APPLICATION FOR SUBMITTAL OF POST-APPROVAL DOCUMENT

ADDENDUM NO. 1

**DR. MARTIN LUTHER KING JR. ELEMENTARY SCHOOL WELLNESS CENTER
BAKERSFIELD CITY SCHOOL DISTRICT**

**Project No.: 5527
DSA File No. 15-6
DSA App No. 03-122605
June 19, 2023**

Sheet No.:
E-1.0

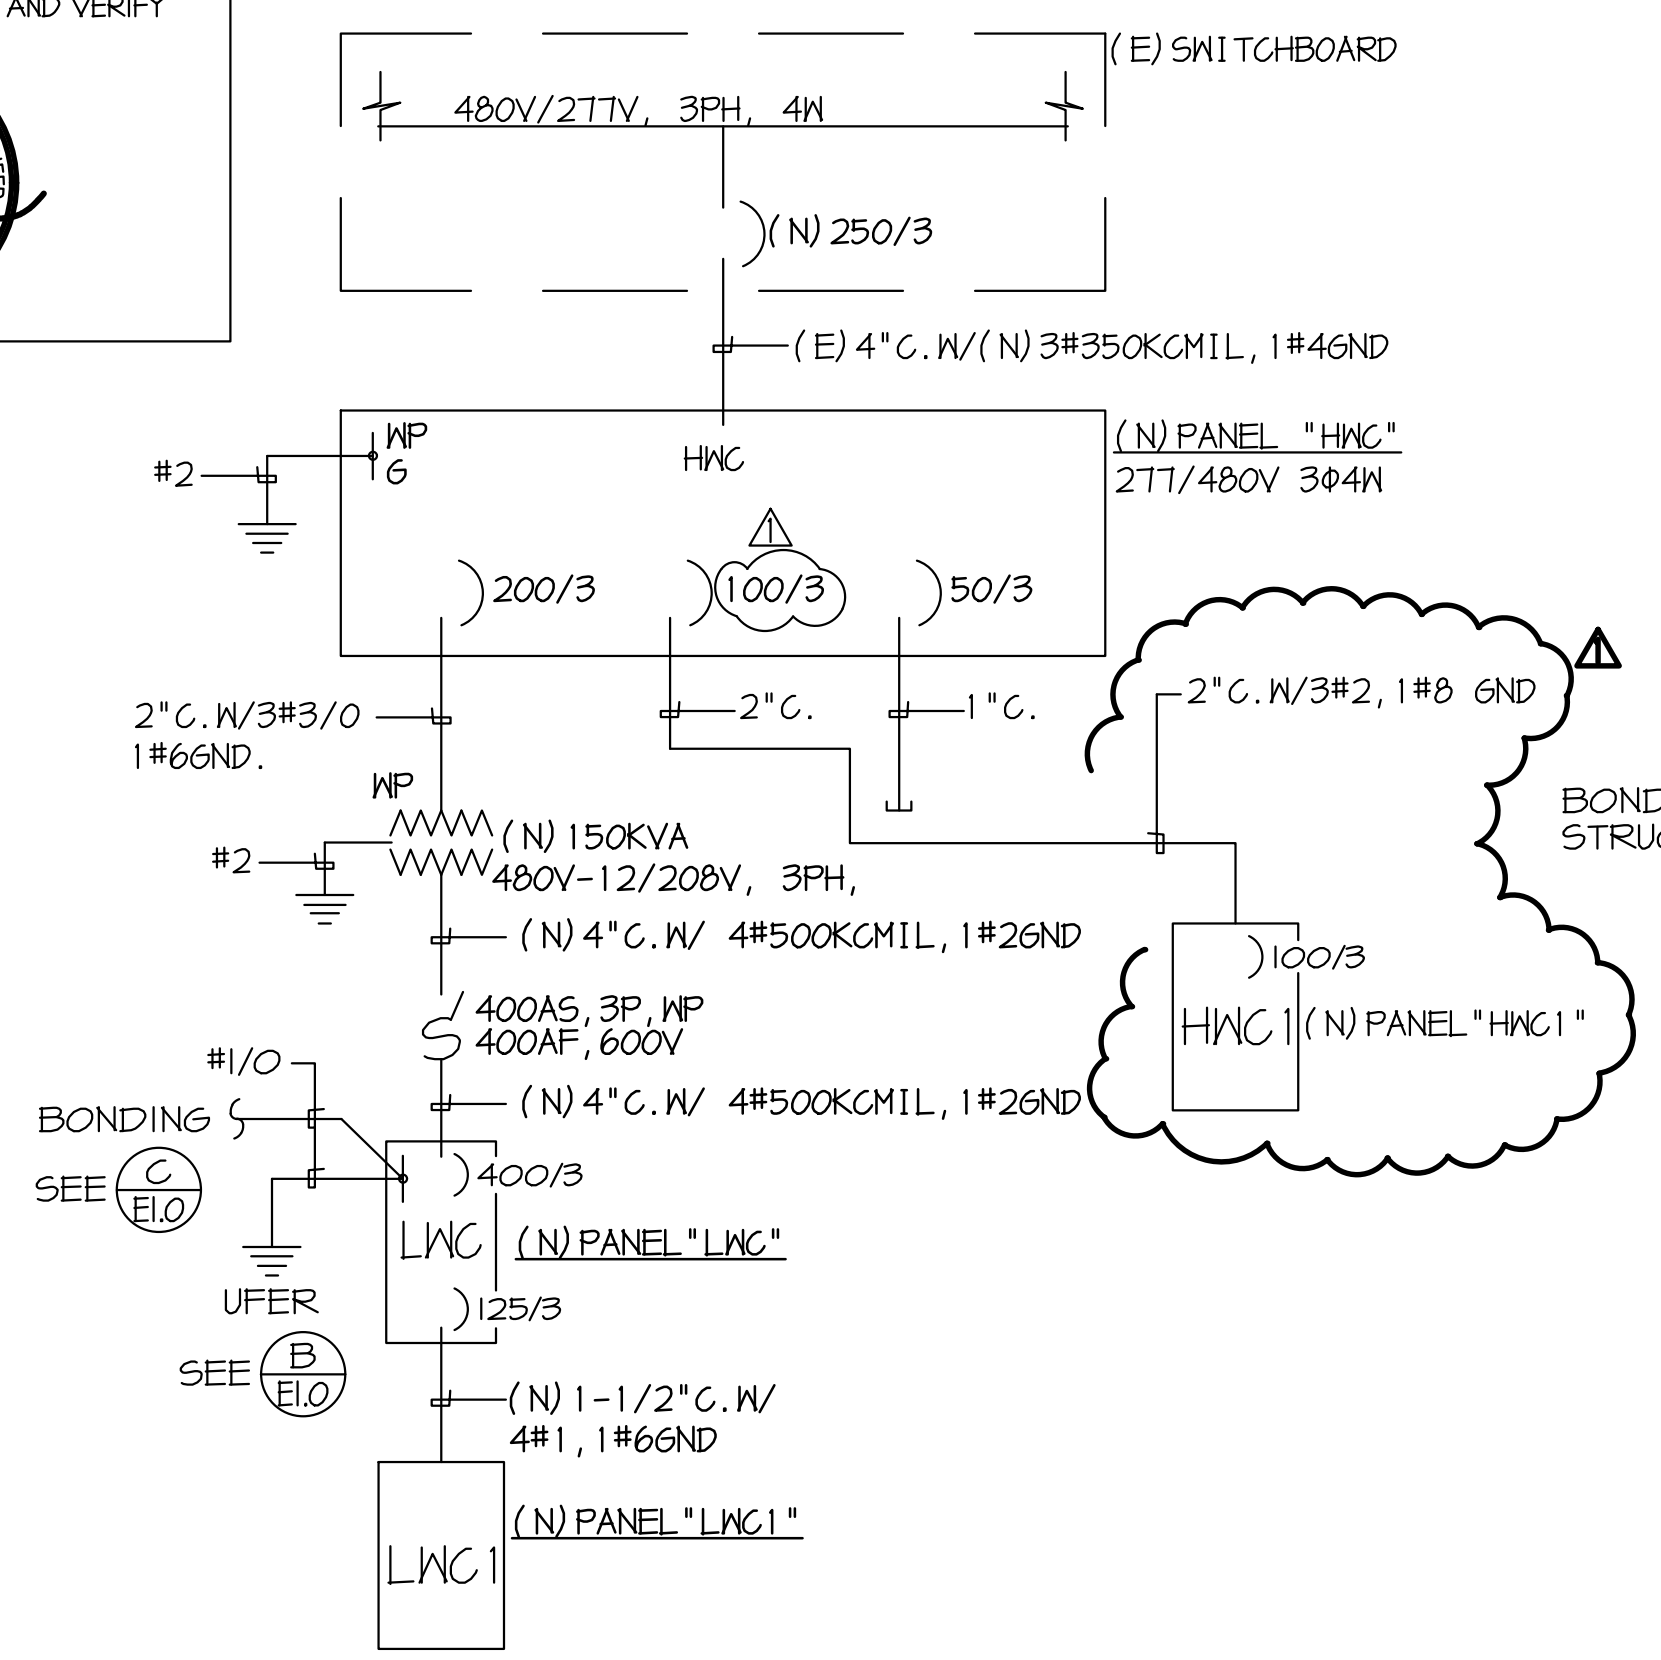
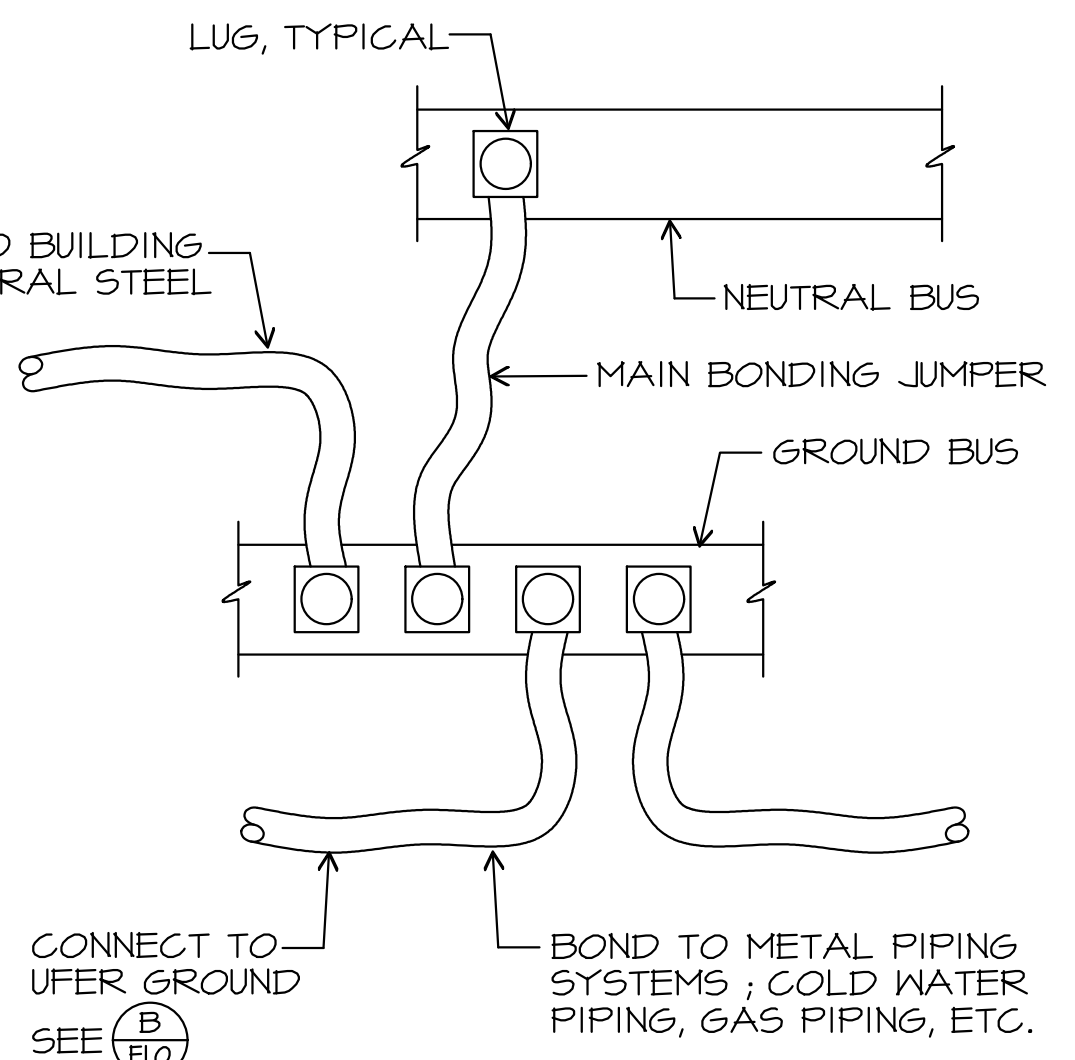
6. CONFIRMATION, DESCRIPTION AND LISTING OF DOCUMENTS:			
For addenda, revisions, or CCDs: CHECK THIS BOX <input checked="" type="checkbox"/> to confirm that all post-approval documents have been stamped and signed by the Responsible Design Professional listed on form DSA 1: Application for Approval of Plans and Specifications for this project. (For Deferred Submittals, refer to IR A-18: Use of Construction Documents Prepared by Other Professionals, and IR A-19: Design Professional's Signature and Seal (Stamp) on Construction Documents, when applicable, for signature and seal requirements.)			
Provide a brief description of construction scope for this post-approval document (attach additional sheets if needed): Addendum No. 1 Replace sheets listed below to revise to 480V			
List of DSA-approved drawings affected by this post-approval document: E-1.0, E2.1, E-4.0

1-01 **REVISE THE FOLLOWING DRAWING IN ITS ENTIRETY WITH NEW DRAWING IDENTIFIED AS ADDENDUM No. 1:** Note clouded areas for revisions.
